# 2024/2047/P & 2024/2090/L

## 42-43 Queen Square

<b>Delegated Report</b> (Members Briefing)		<b>Analysis sheet</b>		<b>Expiry Date:</b>	<b>17/07/2024</b>
		N/A / attached		<b>Consultation Expiry Date:</b>	<b>23/06/2024</b>
<b>Officer</b>			<b>Application Number(s)</b>		
Daren Zuk			i) 2024/2047/P ii) 2024/2090/L		
<b>Application Address</b>			<b>Drawing Numbers</b>		
42-43 Queen Square London WC1N 3AQ			<i>See draft decision notice</i>		
<b>PO 3/4</b>	<b>Area Team Signature</b>	<b>C&amp;UD</b>	<b>Authorised Officer Signature</b>		
<b>Proposal(s)</b>					
<p>i) External alterations to include installation of canopy lift between lower ground and ground floor level; installation of plant at roof level and quench pipe; removal of existing lift; removal of existing ground floor side elevation window and installation of window and door; installation of vents above the stairs and associated external alterations.</p> <p>ii) External alterations to include installation of canopy lift between lower ground and ground floor level; temporary removal of rooflight to install MRI machine and temporary removal of brickwork to lower ground floor front elevation to install cancer treatment machine

Fig 5. Proposed lower ground floor plan showing location of cancer treatment machinery.

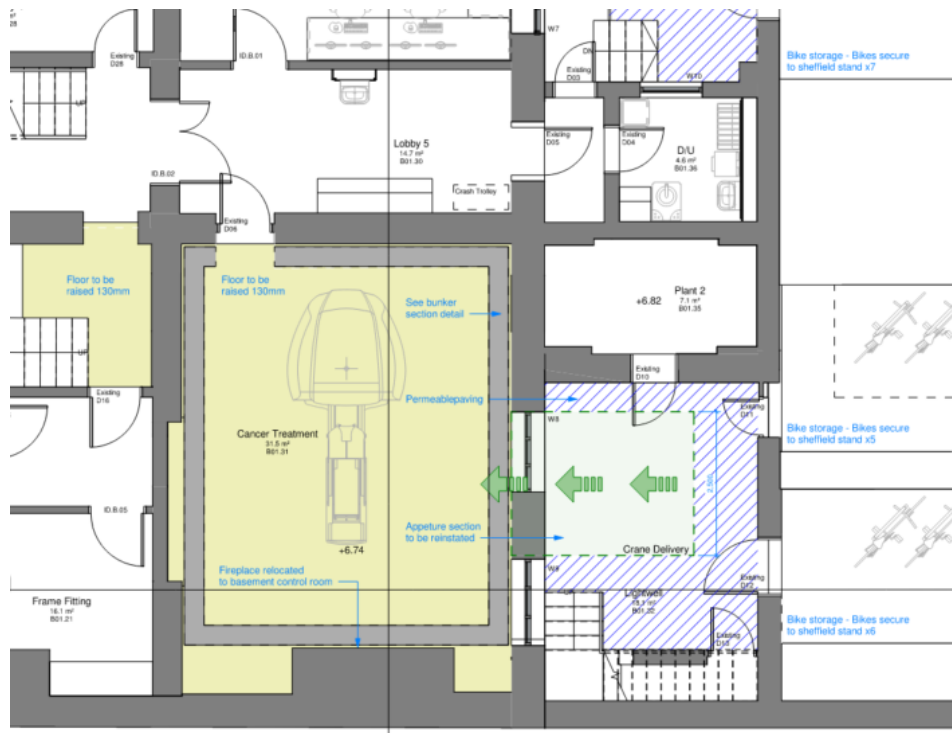
- 4.16. At the basement level, a new cancer treatment machine and associated steel box frame are proposed to be installed in the front room of no.42. This is considered the most appropriate location due to its accommodating floor-to-ceiling height and accessible location for installation of the machinery. While the relocation of chimneypieces within listed buildings is rarely encouraged, in this instance it is considered that relocating the Majolica chimneypiece from the proposed cancer treatment room to the unaffected equivalent room in the neighbouring basement at no.43 is considered acceptable in this instance.

Fig 6. Proposed section.

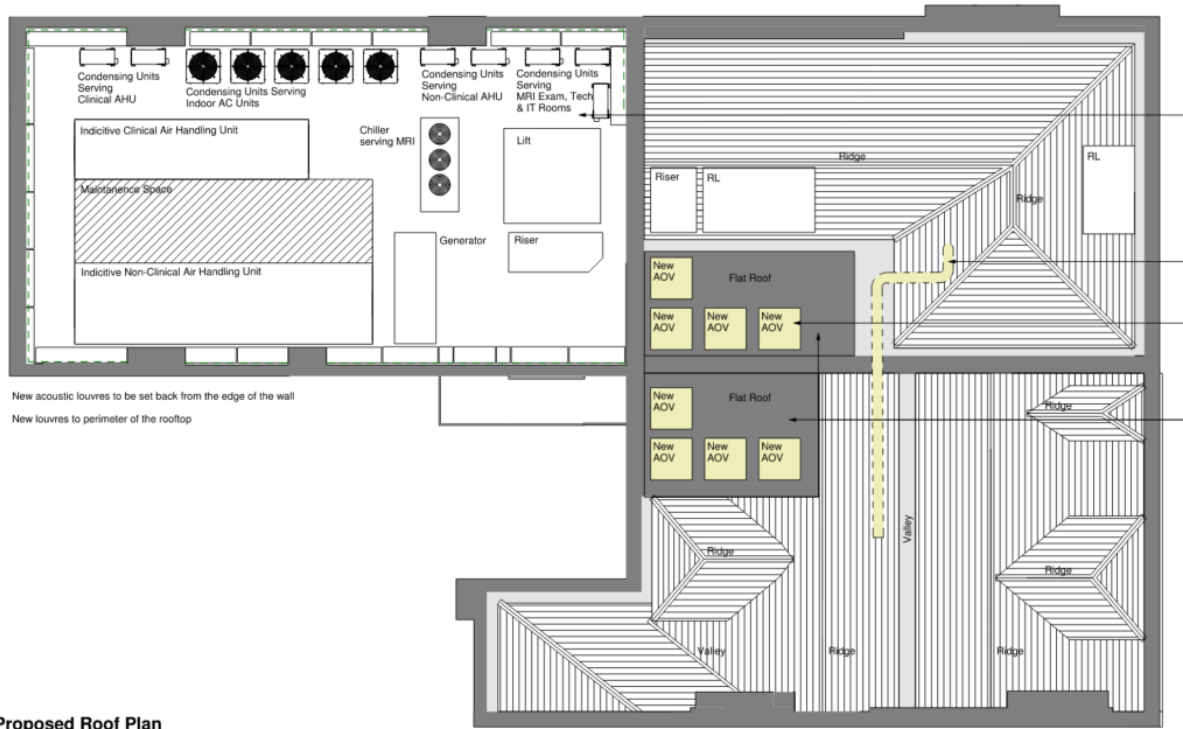
- 4.13. The main external works comprise the partial demolition of the front elevation at the basement level to install a cancer treatment machine in the front basement room of no.42. This would require the temporary removal of historic fabric, with the facade and window being reinstated after installation. The same portion of the elevation would need to be demolished and reinstated periodically (every 5 years) to replace crucial elements of the machinery. The works would require the demolition of historic fabric but are considered to be in the least impactful location as the facade is rendered at the basement level and can be easily replicated, thus minimising the harmful impact on the host building. Although the works would cause less than substantial harm to the host building, the harm can be balanced (as discussed below) against the benefits of the scheme including provision a new healthcare facility. A condition has been included to ensure that the reinstated window and facade treatment will match as closely as possible. An additional condition has been included, which requires the submission of a methodology statement for the removal of the cancer treatment machined and related structures at the end of the lease.

- 7 Prior to the final removal of the medical equipment located at basement level at the end of the lease, a methodology statement, including details of removal and how the internal and external fabric will be reinstated, shall be submitted to and approved in writing by the local planning authority. The relevant part of the works shall not be carried out otherwise than in accordance with the details thus approved.
